# CITY OF ALBUQUERQUE

RE: **Lot 8 Block 13 S.A.D. 227 Unit 5**  
**6514 Jade Dr. NW**  
**Grading and Drainage Plan**  
**Engineers Stamp Date 2/2/2021 (E10D097)**

ENGINEER'S SEAL  DAVID SOULE NEW MEXICO REGISTERED PROFESSIONAL ENGINEER 14622 2/2/21	Lot 8 Blk 13 Un 5 VC 6514 JADE DR. NW  GRADING AND DRAINAGE PLAN  Rio Grande Engineering P.O. BOX 53924 ALBUQUERQUE, NM 87199 (505) 321-9099	DRAWN BY DEM
		DATE 2-2-21
DAVID SOULE P.E. #14522		Lot 8 Blk 13 Un 5 VC DWG
		SHEET # C1 JOB #

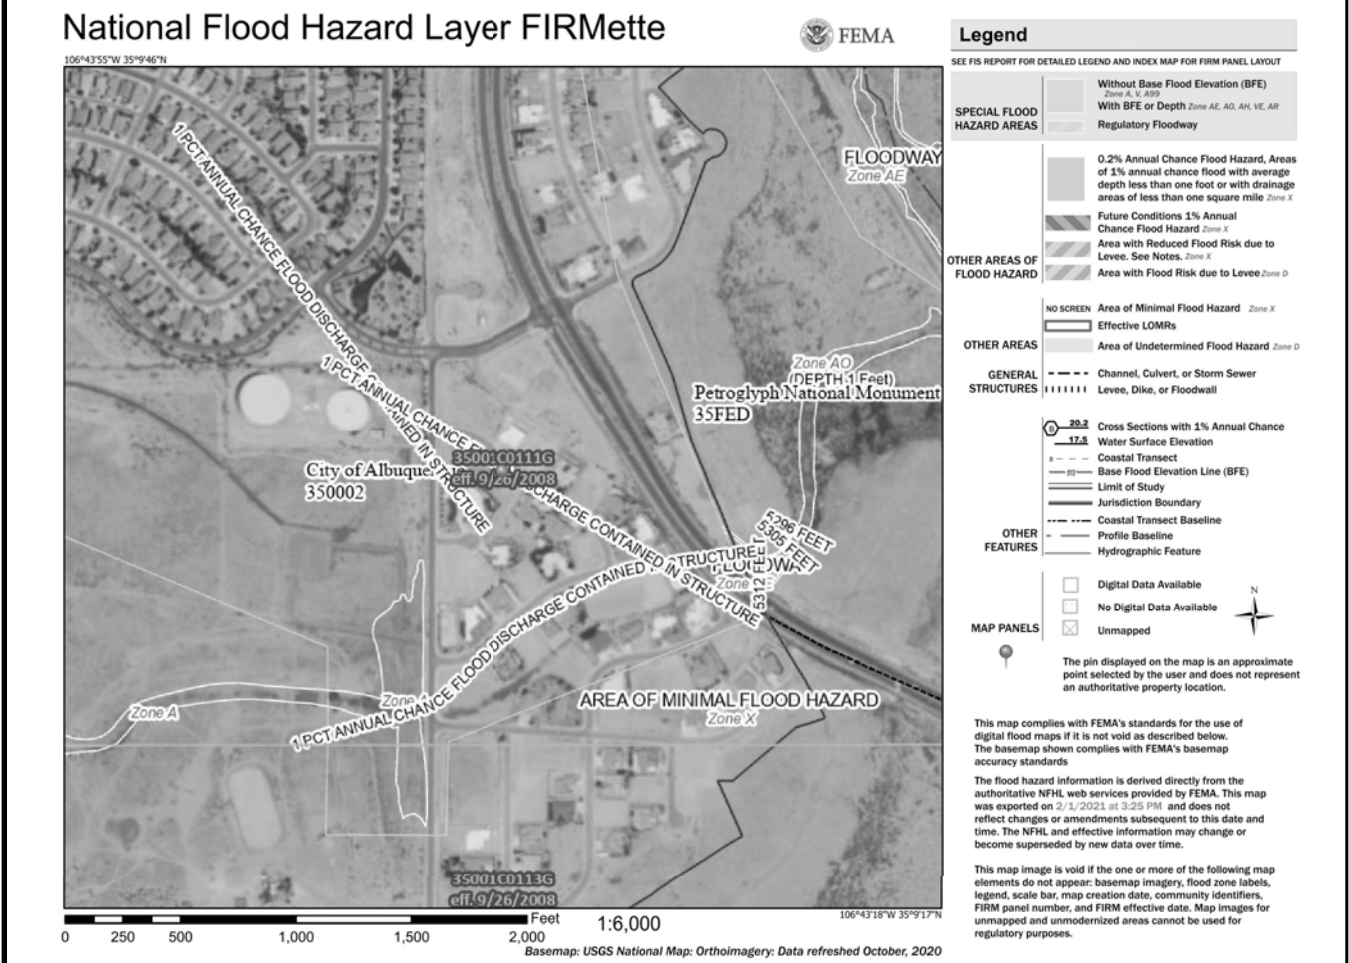
**Reiterate to the Owner/Contractor that a separate permit for any garden/retaining wall must be obtained, with the approved G&D plan. Advise the owner contractor not to use dirt as a ramp to climb the curb, use lumber or crusher fines for this purpose. Also, let the owner/contractor know that if a pool is to be added in the future the G&D plan will need to be modified showing the location of the pool and the land treatment differences.**

Prior to Building Permit approval, a **Pad Certification** will be required. Inform the contractor/owner not to pile dirt in the street as a ramp to climb the curb. If dirt is found in the street the pad cert. will be denied.
